PLANNING COMMISSON
REGULAR MEETING AGENDA

400 Sixth Street	**March 3, 2025**	**7:00 PM**

Subject: **Rochester Community House/816 Ludlow/Site Plan and Special Exception Review**; revised site plan dated 1/30/2025.

LANDSCAPE PLAN

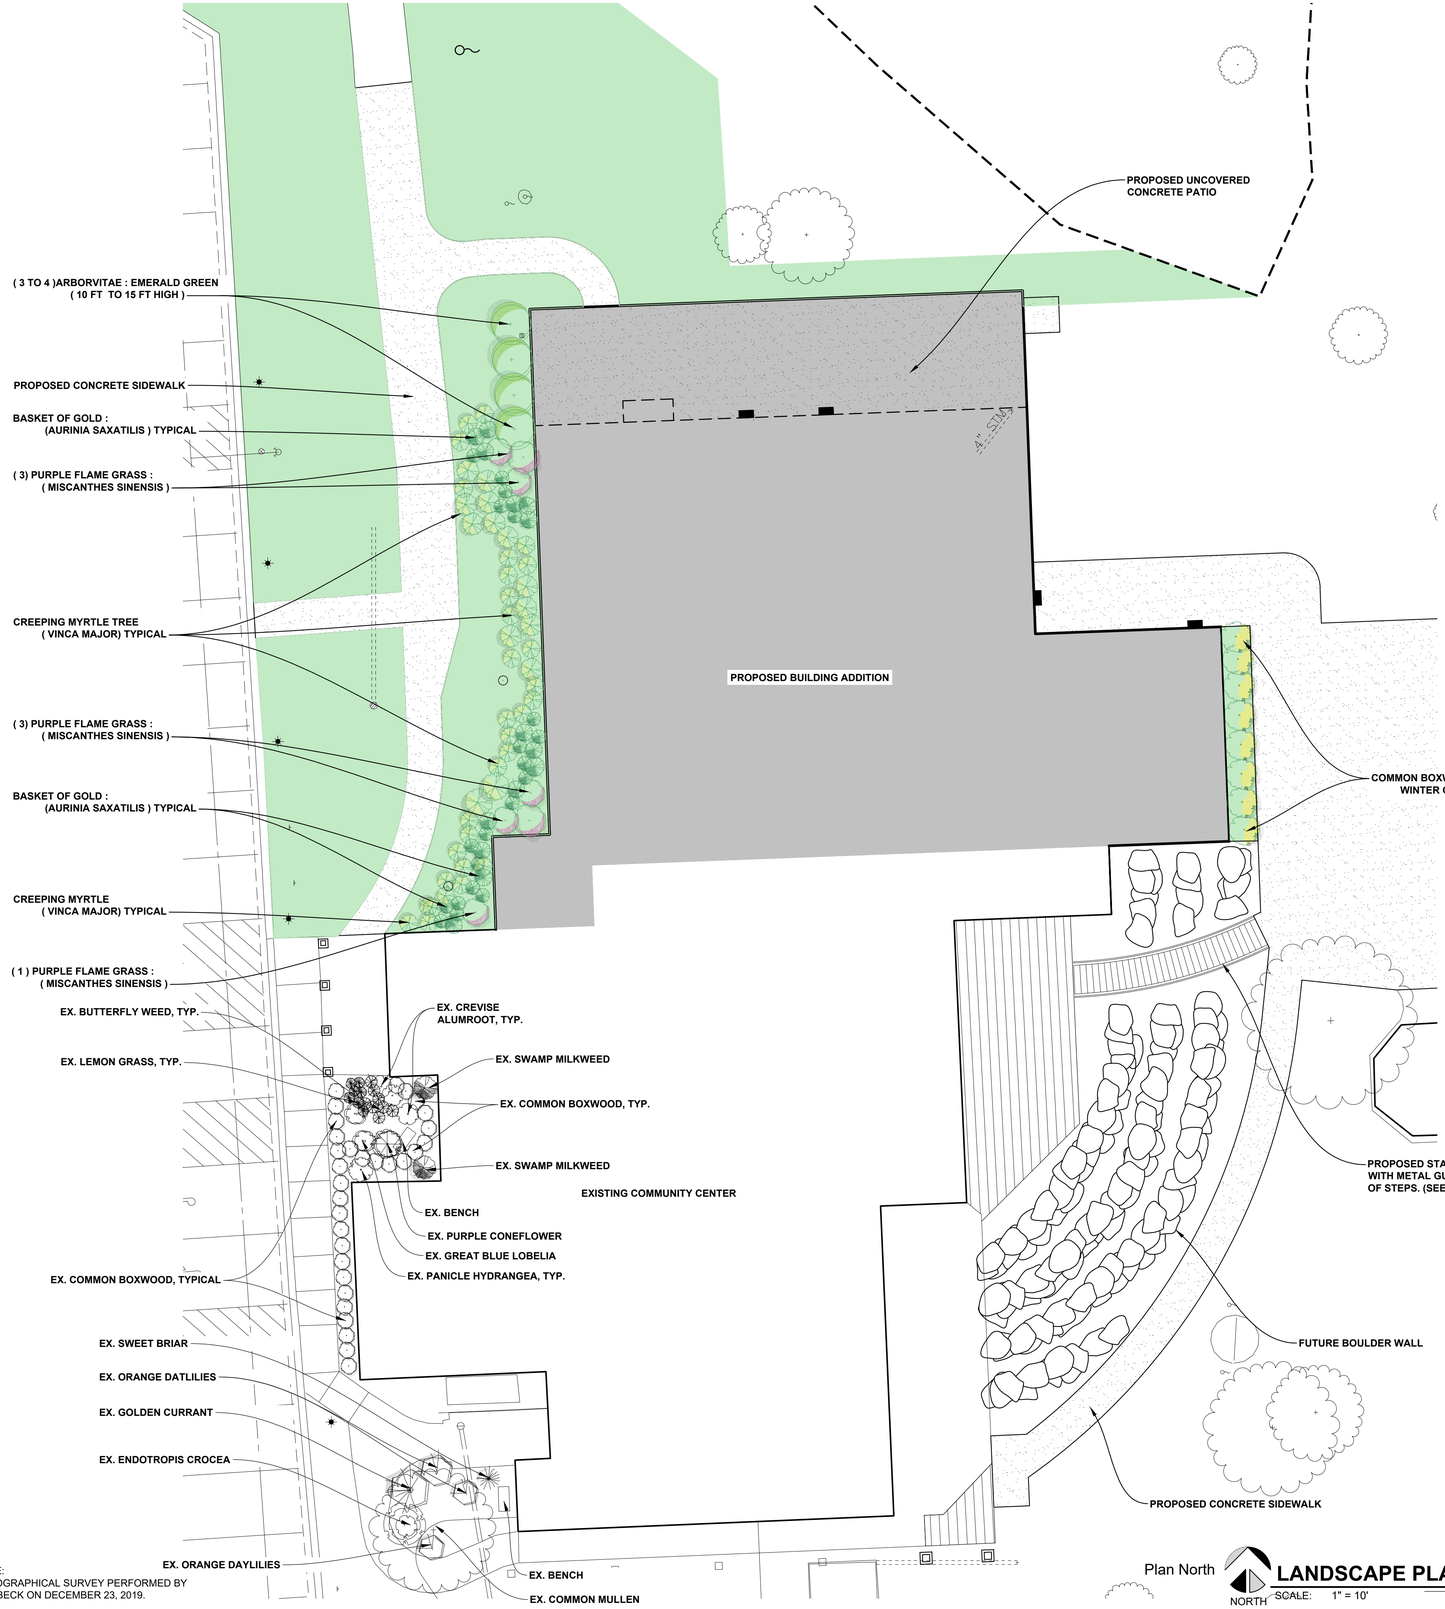
6. **Landscaping.** The applicant has submitted an extensive landscape plan which proposes the installation of numerous ornamental trees, perineal shrubs, evergreens, and ornamental grasses along the foundation of the building on the west side. The plan includes an upper deck on the east side of the building with stairways leading to the lower deck and patio area. The plan notes a multi-step boulder wall in this area. The wall however, is labeled as "future boulder wall". The applicant must clarify the timeline for construction of the wall to the Planning Commission and note the treatment of the area until such time the wall is actually constructed to prevent erosion on that slope. All landscape areas are proposed to be provided with automatic irrigation, excluding the boulder terrace landscaping. The plan does not include a landscape maintenance agreement; however, the site is part of the city owned municipal park, which would ensure its maintenance by the city or the applicant.

7. **Tree Removal.** The landscape plan includes a tree survey with 45 trees in the area of disturbance, of which 12 trees are proposed for removal (4 already removed) and a total of 6 trees require replacement. Required replacement calculations have been added stating the need for 29 trees. Since the subject site is part of the larger Municipal Park, the applicant has noted that the trees will be replaced elsewhere in the park at a later date.

EXTERIOR ELEVATION
SCALE: 1/4"=1'-0"

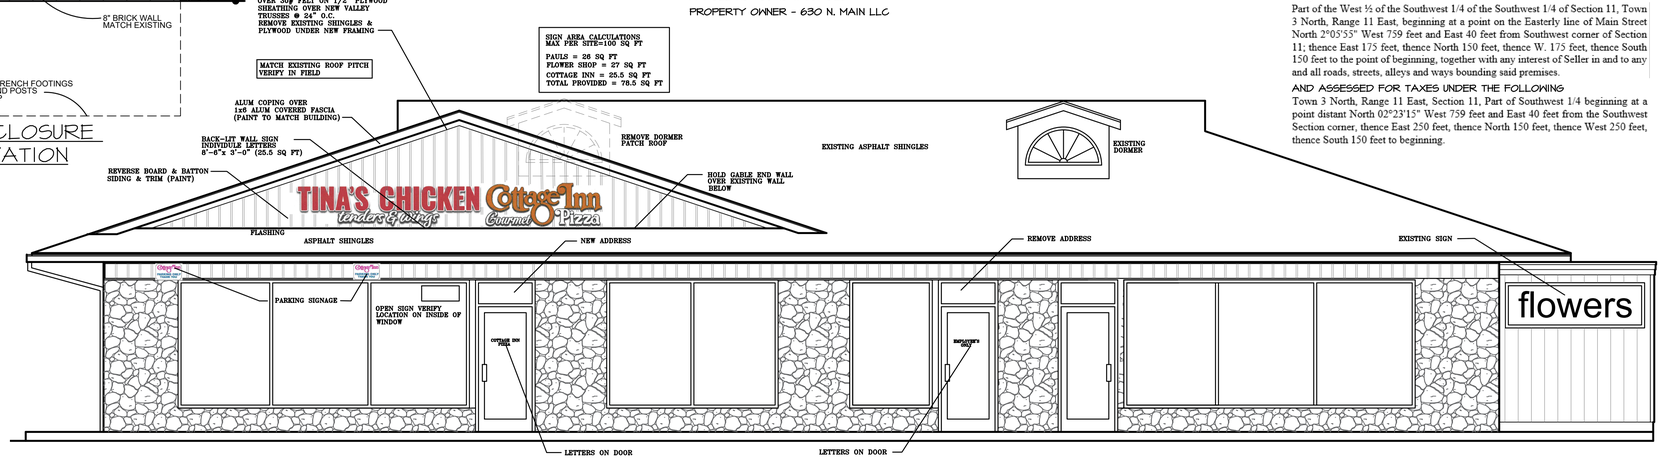
13. ***Sheet A2 includes partial elevation n of the west façade showing proposed...***
    Entire elevation shown.

14. ***Sheet A2 appears to indicate significant wall signage for the new business...***
    Wall signage detailing shown.
